Exhibit MB-50

Exhibit MB-50 aTypical Road

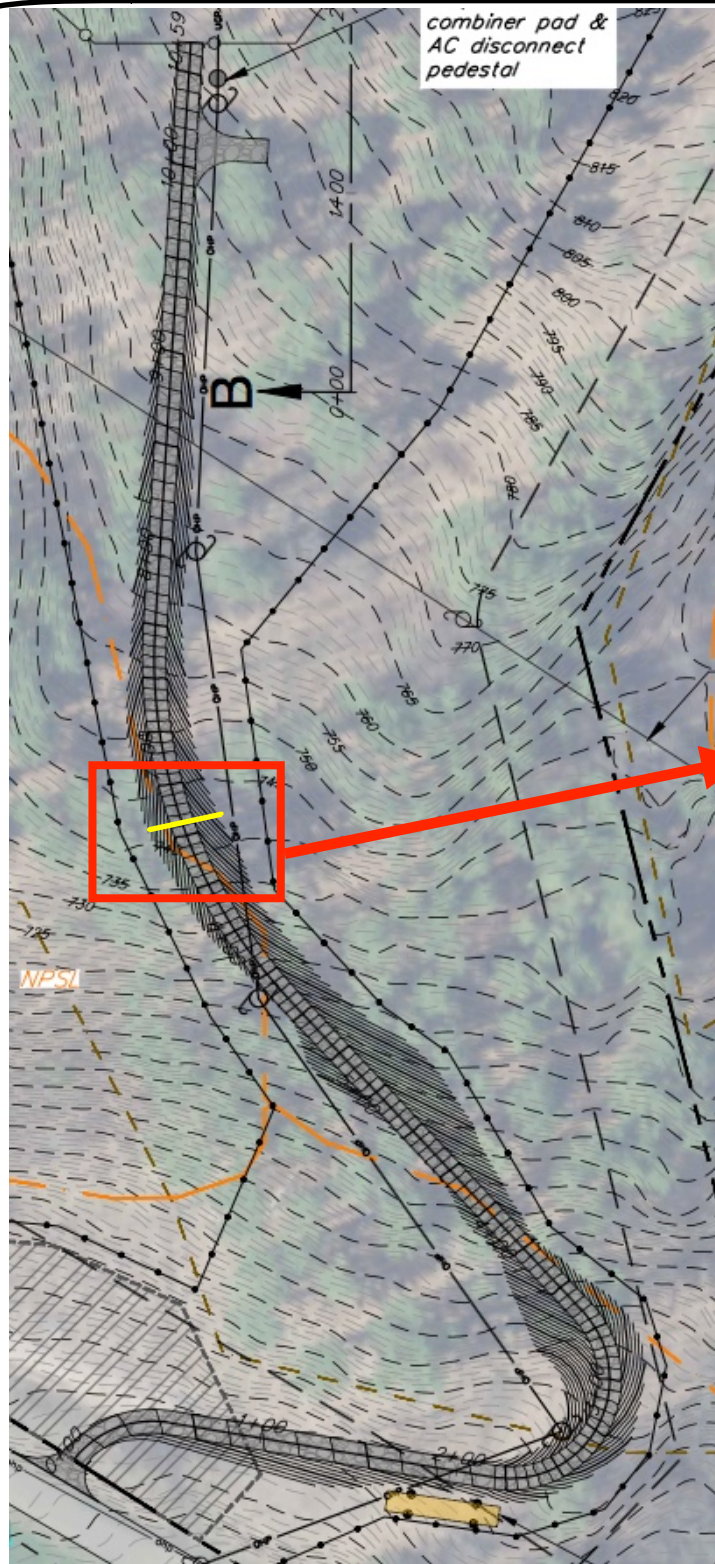
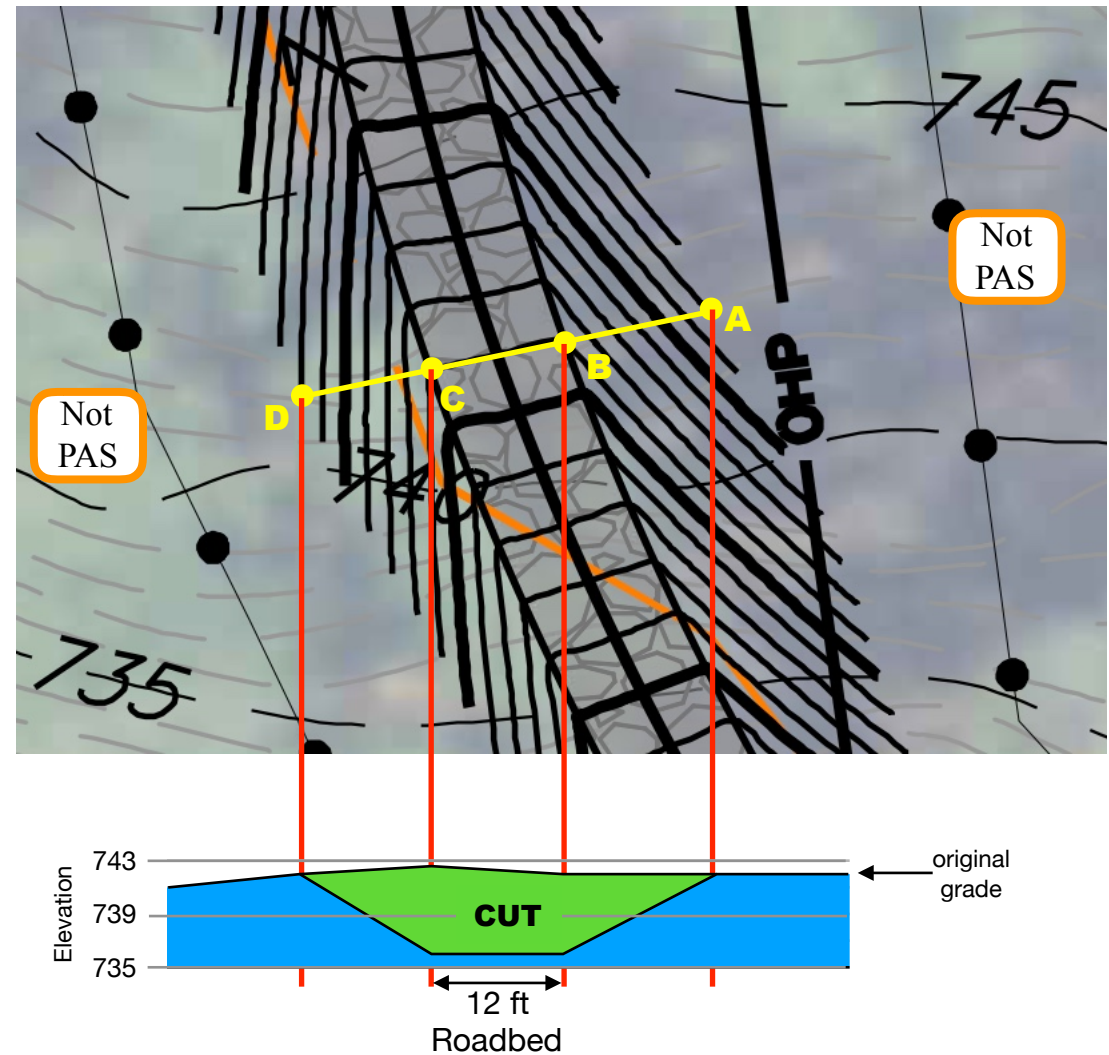
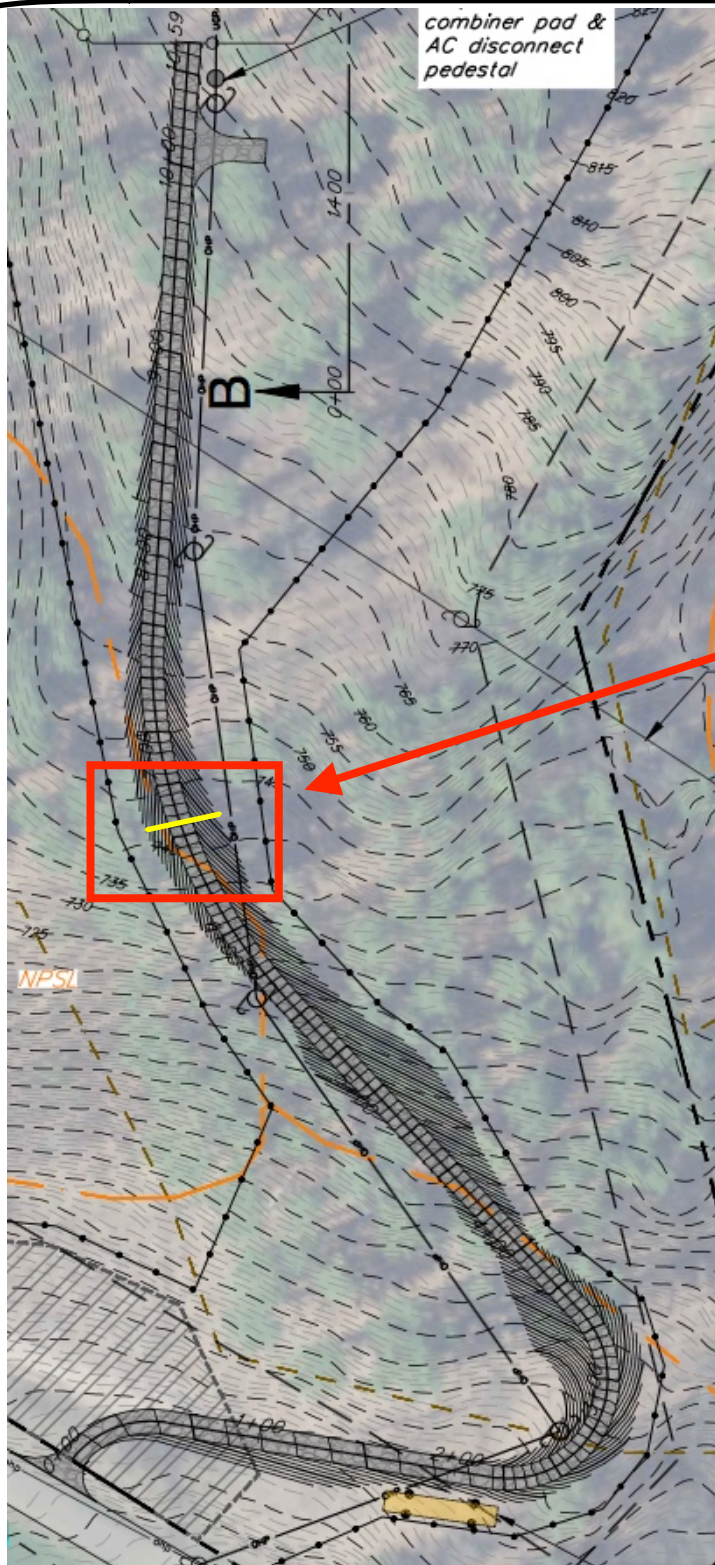
**This is not Cut & Fill,
this is Cut & Cut.**

**The developer proposes to locate the
roadbed on the bottom of a trench
that is over 6 feet deep!**

**The road at this location is
in a 6 foot deep trench
going directly uphill on a
24% grade!**

This will degrade watershed resiliency.

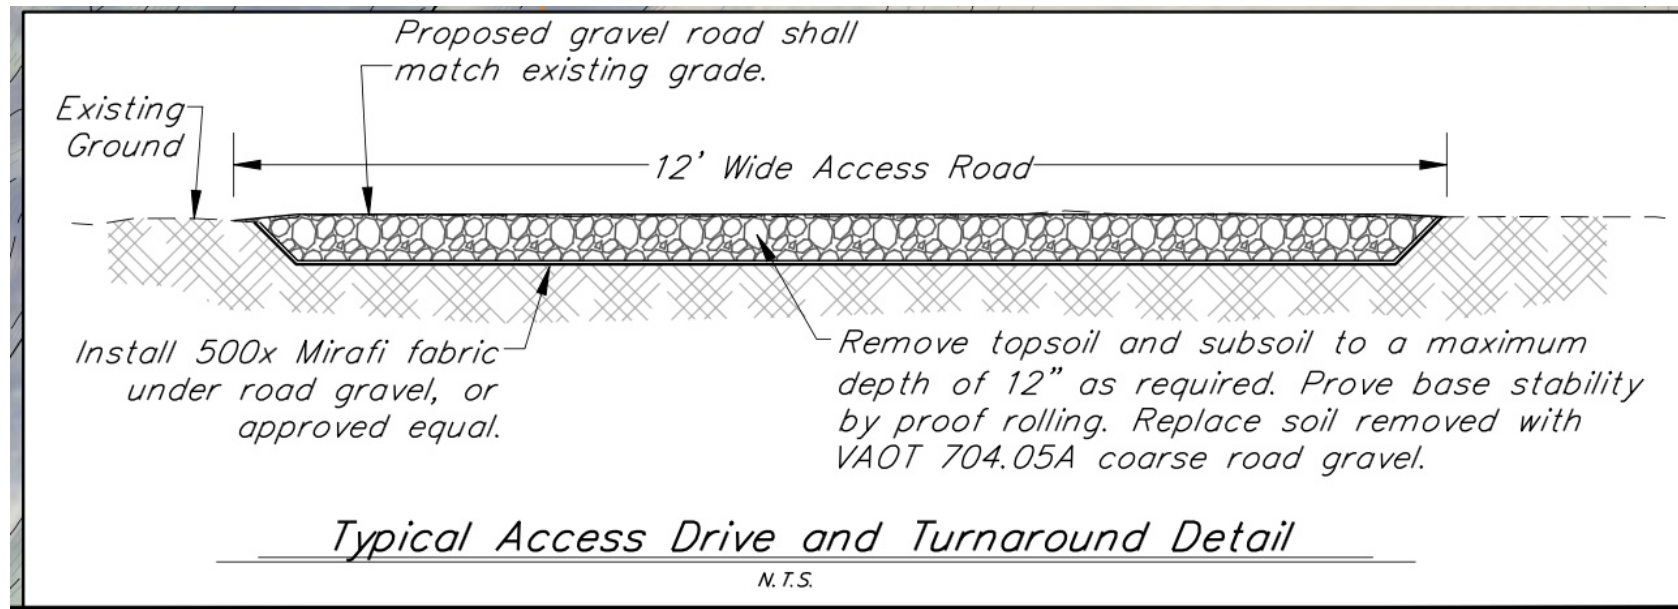
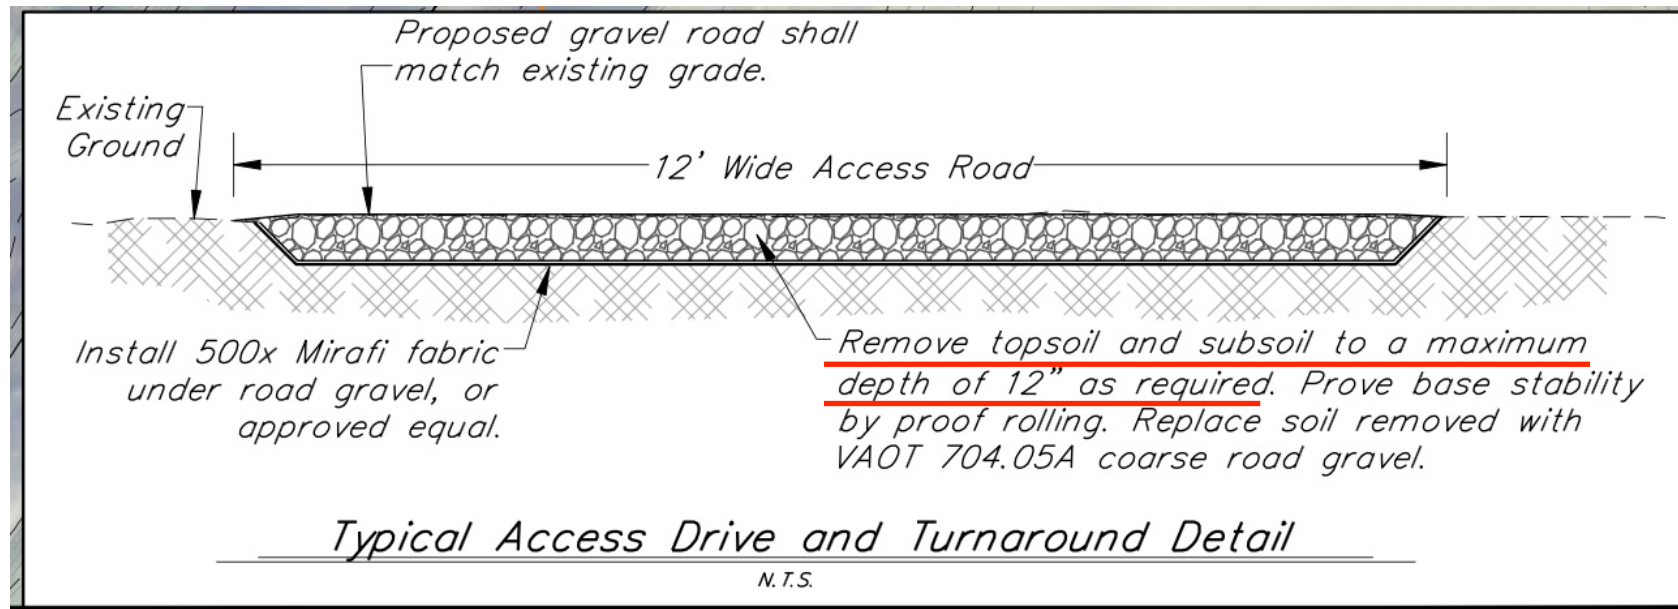
This is the cross section of the road which has remained unchanged through 6 site plans.

The road will end up at the bottom of a 6 foot deep trench after a maximum of 12 inches of soil is removed.

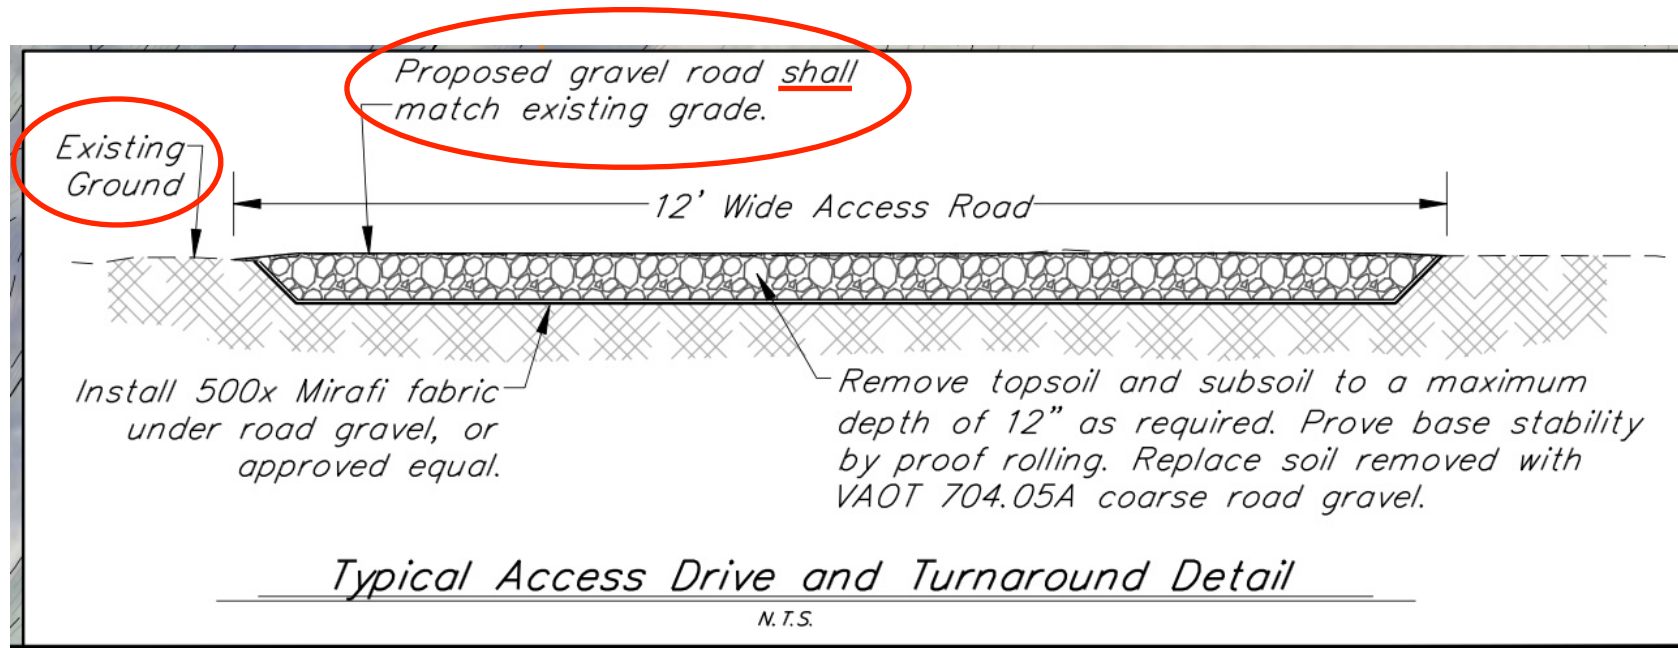
On PAS (which is supposed to be reclaimed at decommissioning), removing soil “as required” means not removing it, but instead burying it up to 9 feet deep.

Some stretches of the road apparently match the existing grade by being at the bottom of a 6 foot deep trench.

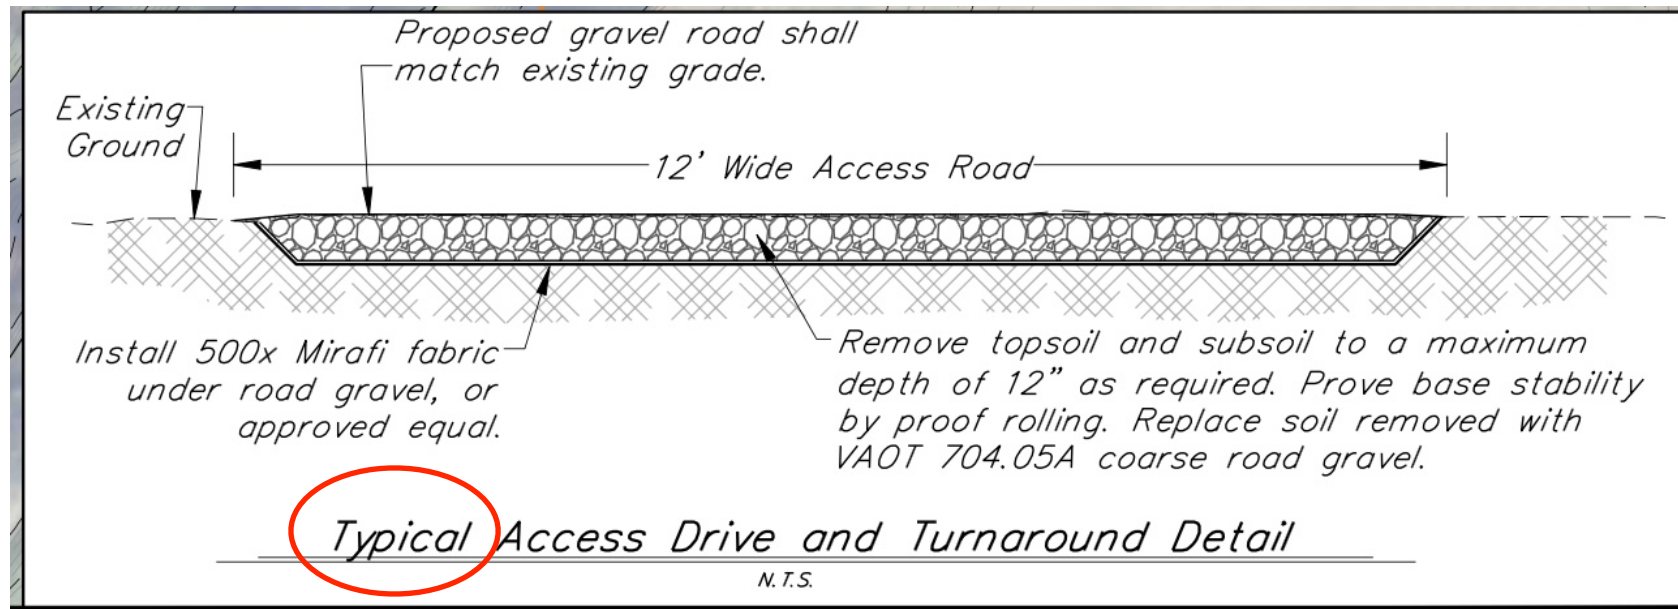
Other stretches of the road apparently match the existing grade by being at the top of a 9 foot high berm.

A novel use of the word “Typical”
